STAFF RECOMMENDATION
934 McFerrin Avenue
March 21, 2018

Application: Demolition—primary structure; New construction-infill
District: Greenwood Neighborhood Conservation Zoning Overlay
Council District: 05
Map and Parcel Number: 08208010200
Applicant: Root Arch
Project Lead: Melissa Baldock, melissa.baldock@nashville.gov

Description of Project: Application is to demolish a non-contributing house and to construct a development with six structures and twelve residential units. **Recommendation Summary:** Staff recommends approval of the demolition of the existing structure on the lot, finding that its demolition meets Section III.B.2. of the design guidelines. Staff recommends disapproval of the new construction, finding that the proposed development does not meet Sections II.B.1.a (Height), II.B.1.b. (Scale), II.B.1.c. (Setback & Rhythm of Spacing), II.B.1.f (Orientation), II.B.1.g. (Proportion and Rhythm of Openings), and II.B.1.k. (Multi-unit Detached Developments/ Cottage Developments) of the design guidelines for the Greenwood Neighborhood Conservation Zoning Overlay.	**Attachments** **A:** Photographs **B:** Site Plan **C:** Elevations

Figure 5. Proposed site plan.

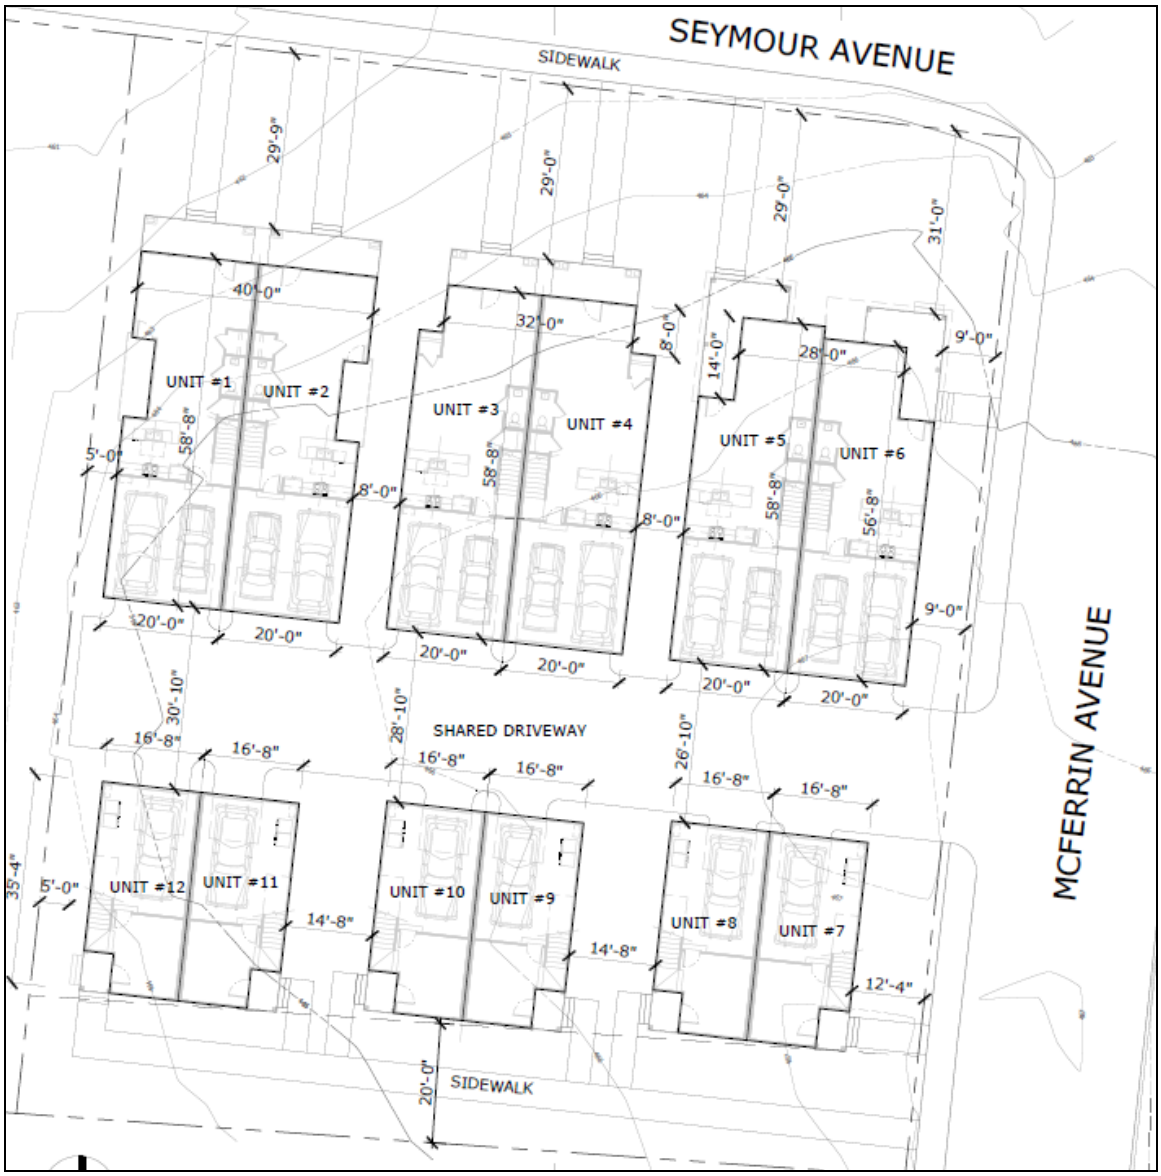
The proposed development will be largely oriented to face Seymour Avenue, which is appropriate (Figure 5). There will be three duplex structures facing Seymour Avenue. At the back, there will be three smaller structures also containing two residential units each. Vehicular access to the site will be via new curb cut and shared driveway off of McFerrin, towards the back of the lot, in between the two sets of structures. The driveway is approximately twenty-nine feet (29') at the street. Typically the Commission has not allowed for driveways that exceed twelve feet (12') in width. Because of the density of the lot, staff finds the wider drive to be appropriate but is concerned about its visual impact on the historic neighborhood. Each unit will have attached parking, which is not typically allowed for the front units, but staff finds it to be appropriate in this instance because of the density of the site.

Most of the units facing Seymour Avenue have walkways leading from the front porches to the sidewalks. However, Unit 6, which is located at the corner of McFerrin and Seymour Avenue, has a corner entrance and one walkway leading to the sidewalk along McFerrin Avenue. In order for the project to meet the design guidelines and to address both streets, Unit 6 should have one walkway to Seymour Avenue and one walkway to McFerrin Avenue.

The units facing Seymour Avenue all have front porches that are a minimum of six feet (6') deep. Units 1 and 2 share the same porch roof, but have porch floors that are separated by two feet (2') of space. Units 3 and 4 have a similar porch configuration. In looking at historic duplexes, typically, either the porches shared the same floor and the same roof, or the porch roofs and the porch floors were entirely separate. Staff finds that the separate porch floors under the continuous porch roof increase the perceived width of the houses and are not appropriate.

At the rear of the lot, a new walkway will be added, providing access to the rear units. Of the rear units, only Unit 7 will have street frontage. For that unit, the entrance will face McFerrin Avenue, and there will be a walkway leading from the McFerrin sidewalk to the entrance. Staff finds this to be appropriate.

While the project does meet all base zoning setbacks, staff has concerns about the spacing of the structures on the lot. First, staff notes that the site plan does not reflect the current sidewalk regulations for new development in this neighborhood. Neither Seymour nor McFerrin Avenue has sidewalks currently. According to the Metro Planning Department, the development should have a six foot (6') grass strip along McFerrin at the edge of the street and then a six foot (6') sidewalk, for a total width of twelve feet (12'). Along Seymour, there should be a four foot (4') grass strip at the edge of the street and a five foot (5') sidewalk, for a total width of nine feet (9'). The site plan shows a five foot (5') sidewalk along both McFerrin Avenue and Seymour Avenue, with no grass strips.

The wider sidewalk requirements will affect the setbacks of the structures, particularly along McFerrin Avenue where the Unit 6 (facing Seymour Avenue) is just nine feet (9') from the side property line. Given the required sidewalk width along McFerrin Avenue, Unit 6 should likely be pushed further back from McFerrin Avenue. Staff requires a revised site plan with the correct sidewalk information in order to fully understand the layout of the houses in relation to the sidewalk. The front setbacks, proposed to be twenty-nine feet (29') from Seymour Avenue are likely appropriate, even with the wider sidewalk, since this 800 block of Seymour Avenue does not have any contributing buildings.

Staff also has concerns about the amount of space in between the units facing Seymour Avenue. The applicant is proposing just eight feet (8') in between the structures. Staff finds that this rhythm of spacing does not meet the historic context, where historic houses are generally a minimum of ten to fifteen feet (10'-15') apart, and are often even wider apart. The units facing Seymour Avenue should be a minimum of ten feet (10') apart in order to meet the historic context's rhythm of spacing.

The applicant is proposing twenty-six feet, ten inches (26’10”) in between the houses facing Seymour Avenue and those at the rear. Staff finds that this distance is greater than what is typically required for spacing between primary structures and outbuildings. Staff finds that the spacing between the front and the rear units meets the design guidelines. Likewise, staff finds that the spacing between the side walls of the rear structures, which is fourteen feet, eight inches (14’8”), is appropriate and does meet the design guidelines.

- The eight foot (8’) separation between the units facing Seymour Avenue is inadequate and does not meet the historic context;
- The plans do not include the required sidewalk widths, and the required sidewalk widths will likely mean that Unit 6 should be pushed back further from the McFerrin property line;
- A walkway should be added from Unit 6 to Seymour Avenue;
- The front porches of Units 1 and 2 and Units 3 and 4 have roofs that are connected, but floors that are not, which is a configuration not seen in historic duplexes

For these reasons, staff finds that the proposed development does not meet Sections II.B.1.c. (Setback and Rhythm of Spacing), II.B.1.f. (Orientation), and II.B.1.k. (Multi-unit Detached Developments/ Cottage Developments) of the design guidelines.

SEYMOUR AVENUE ELEVATION - UNITS 1-2

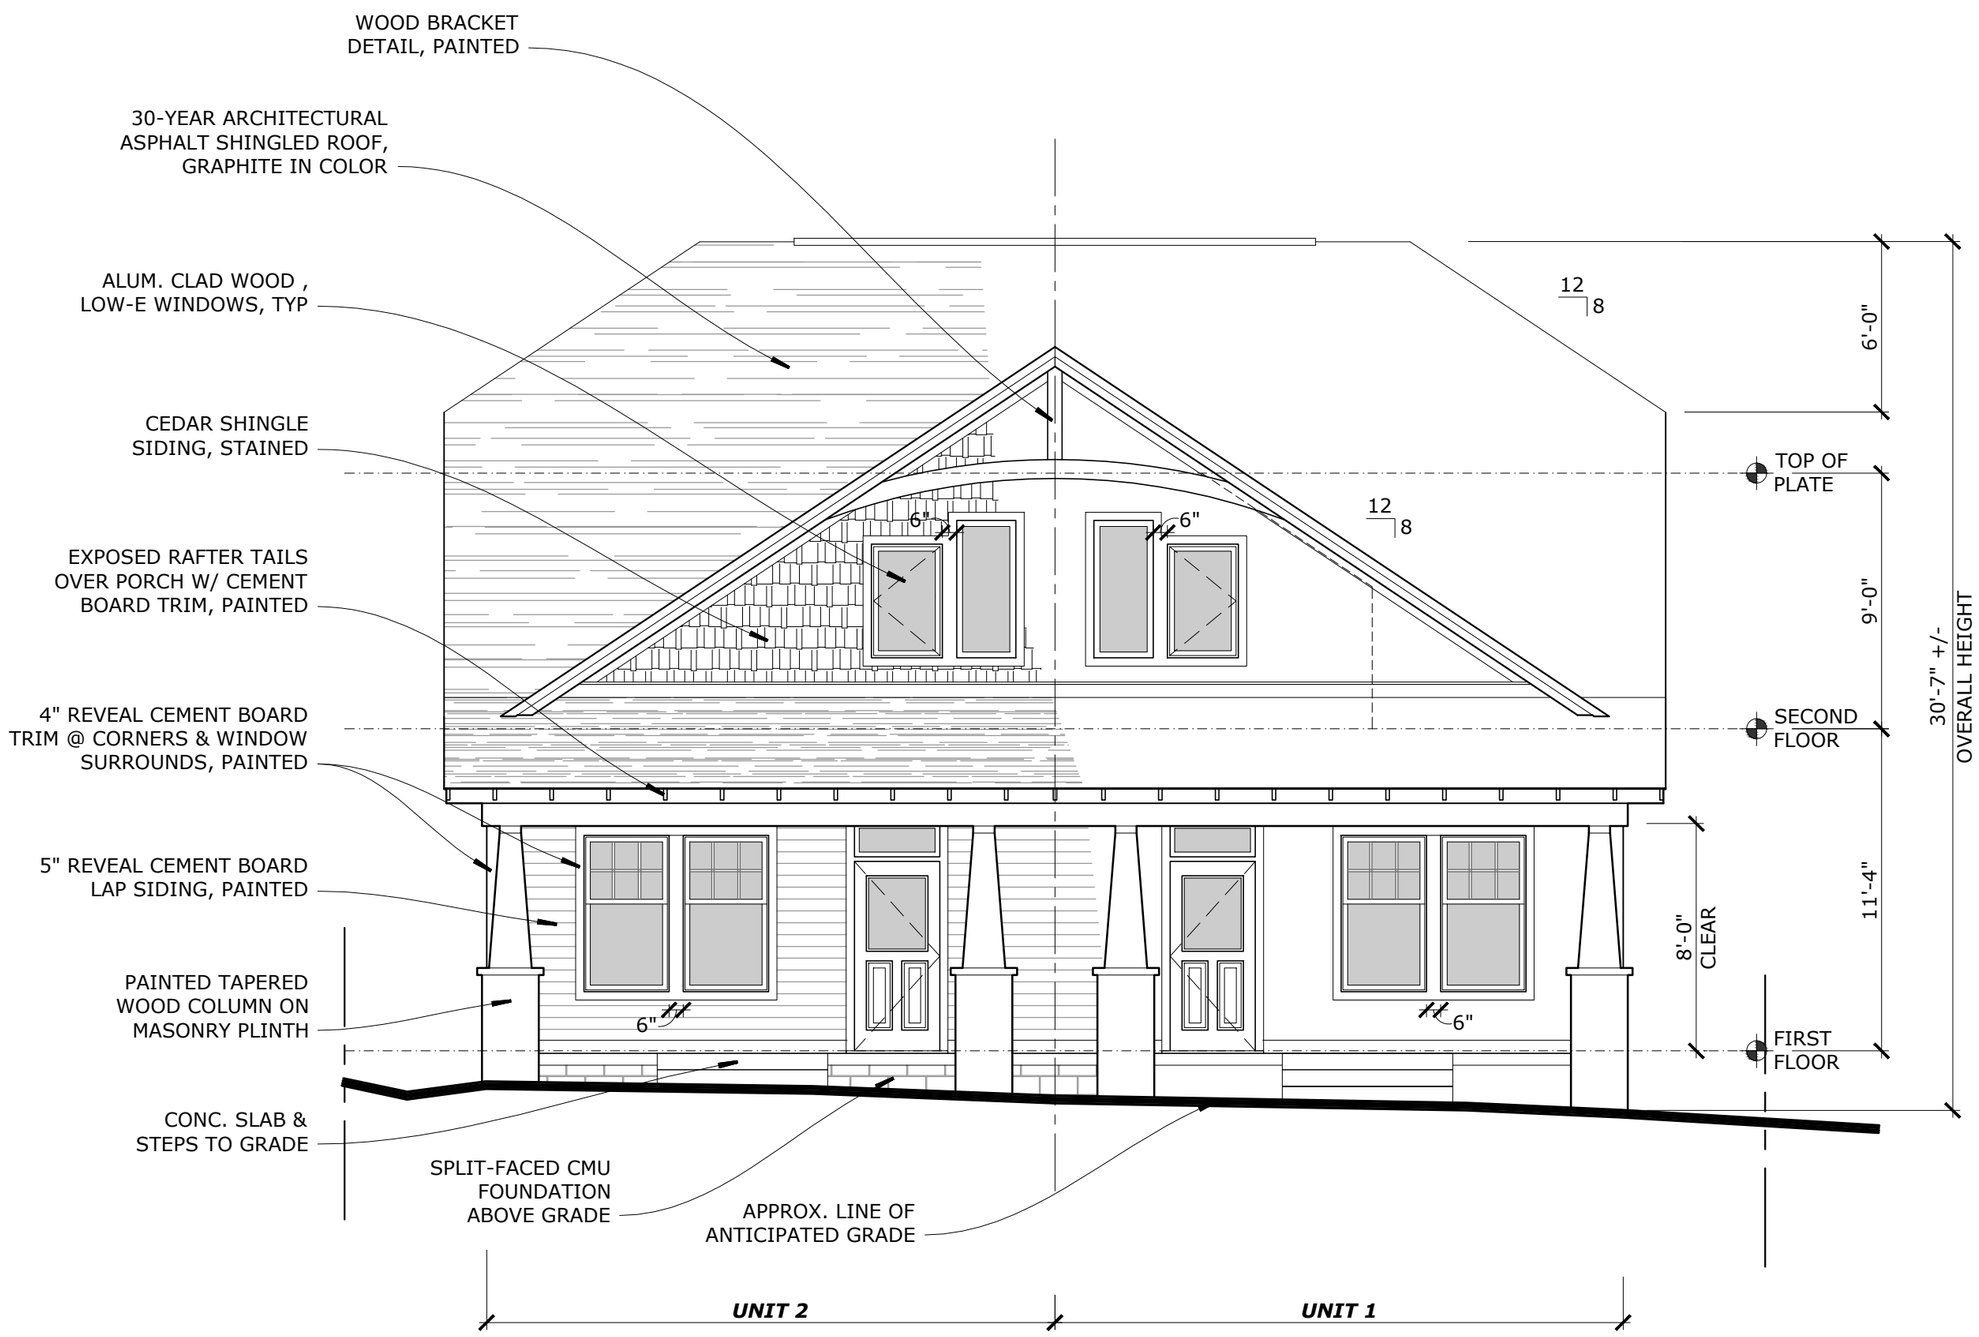
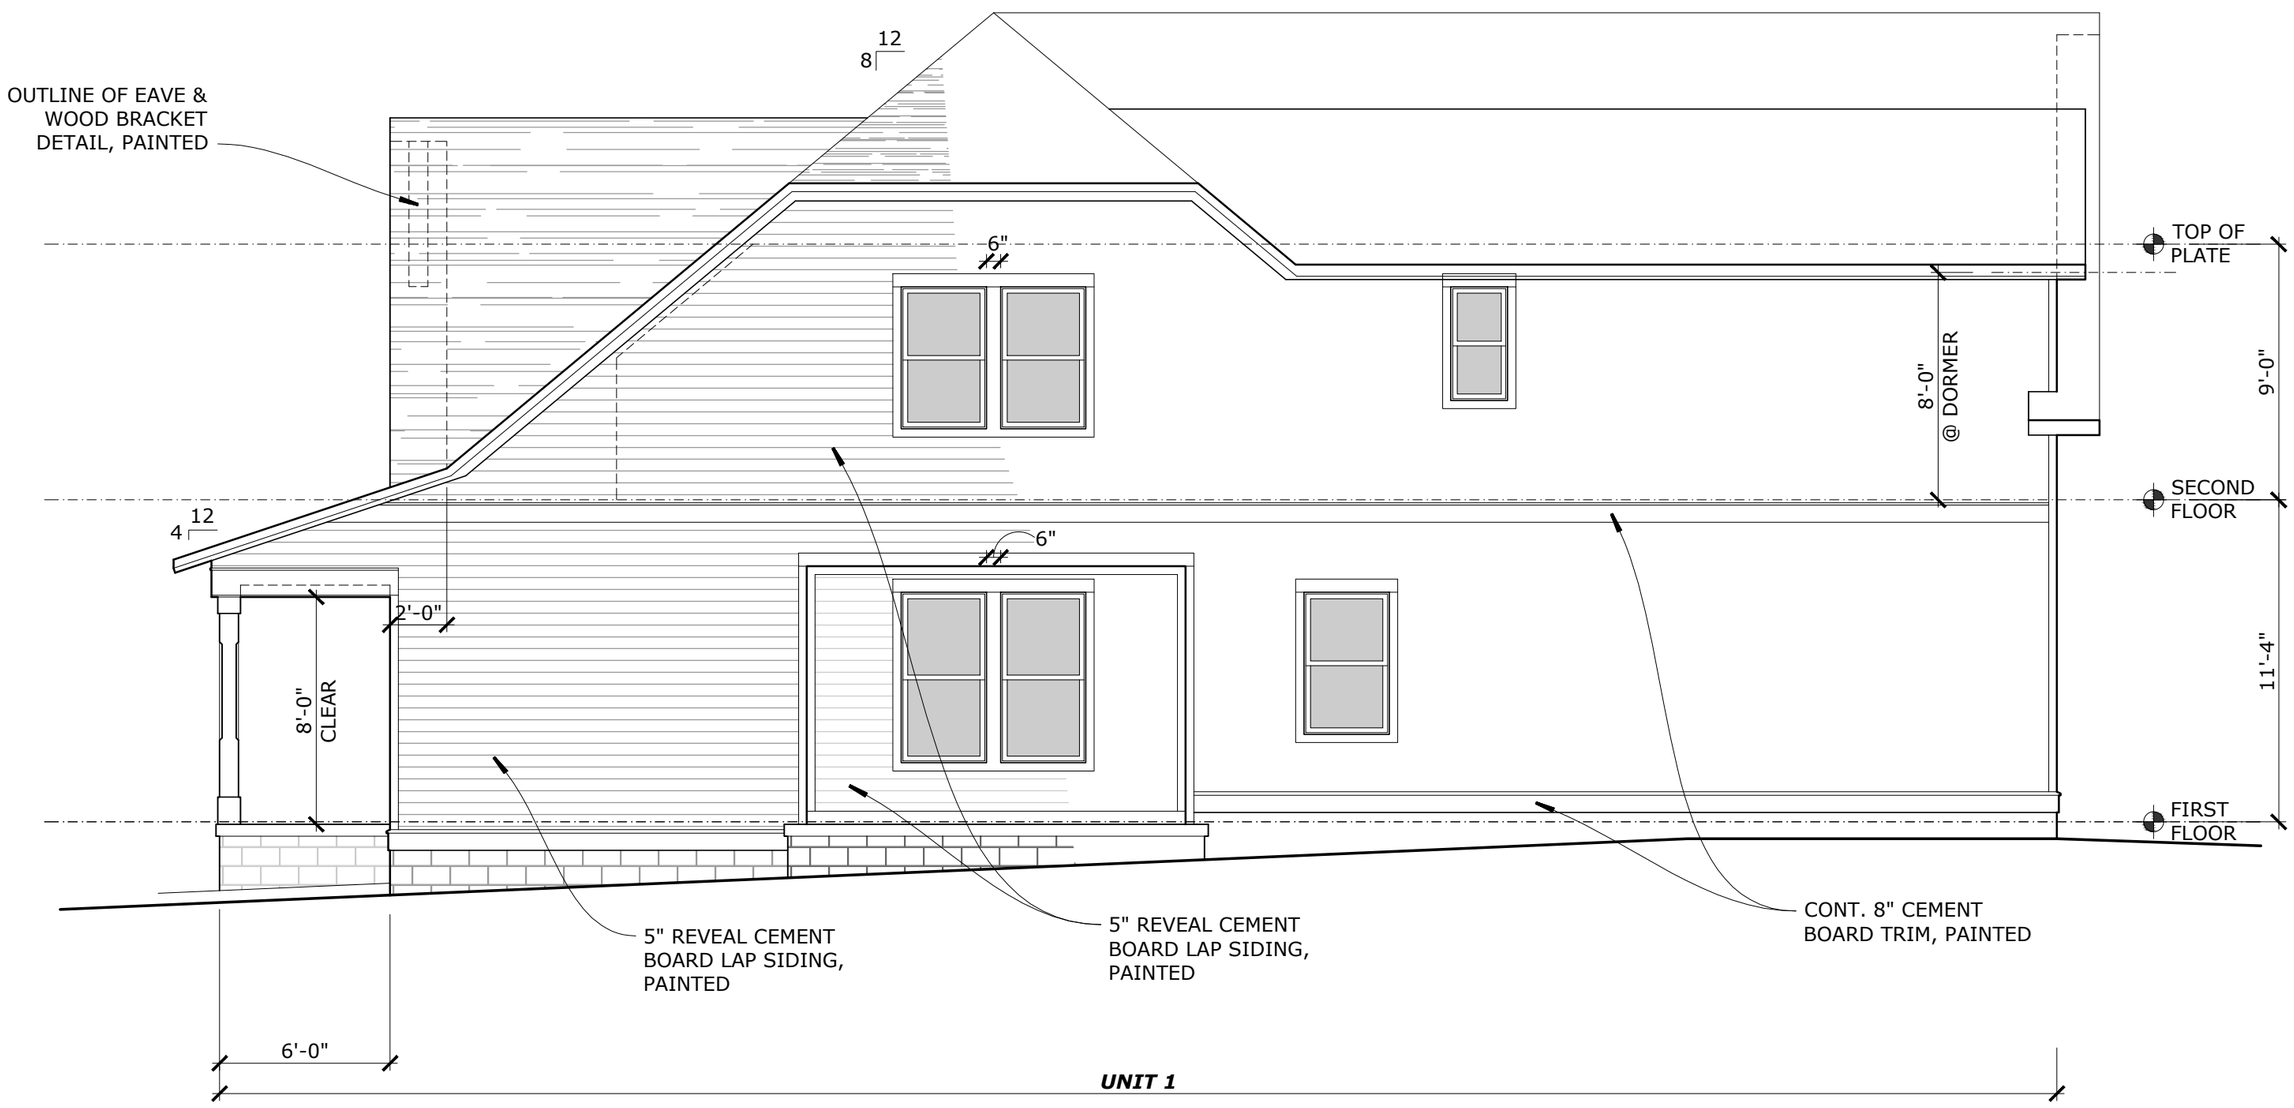
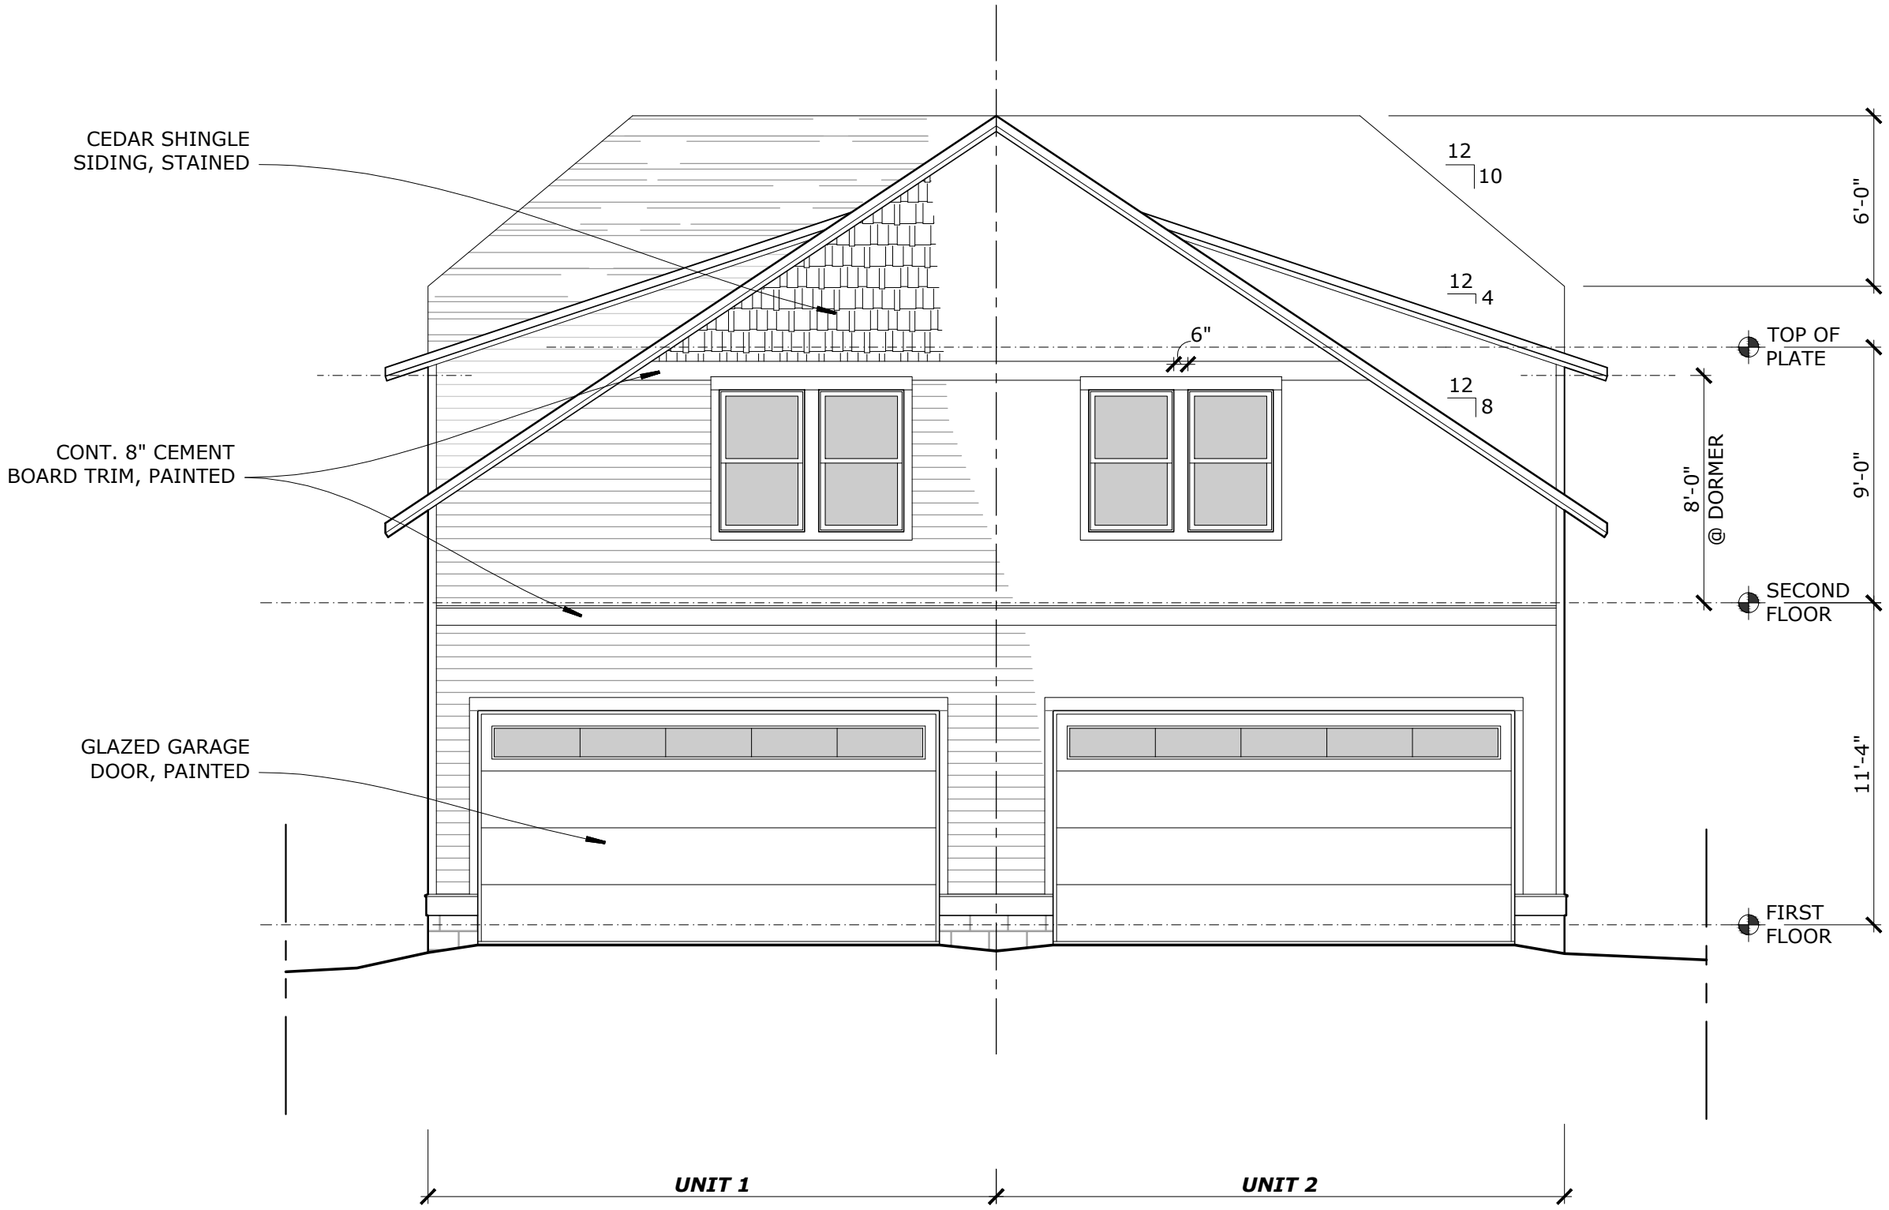
Staff finds that the overall heights and number of stories of the units facing Seymour Avenue could be appropriate, as there are a handful of historic houses that are between thirty and thirty-four feet (30'-34') tall in vicinity and there are no historic buildings on the block-face. However, staff finds the proposed widths of forty feet (40') for Units 1 – 6 are too wide and do not meet the historic context. There are no historic houses wider than thirty-seven feet (37') in the immediate vicinity. Even though Units 3 & 4 and 5 & 6 are designed so that they have a narrower width at the front, the maximum width of forty feet (40') occurs not far back from the front and will be easily perceived on the street. The proposed widths result in houses that are over-scaled for the historic context. Moreover, the widths of forty feet (40') create a situation where the houses are too close together and are too close to the McFerrin Avenue property line.
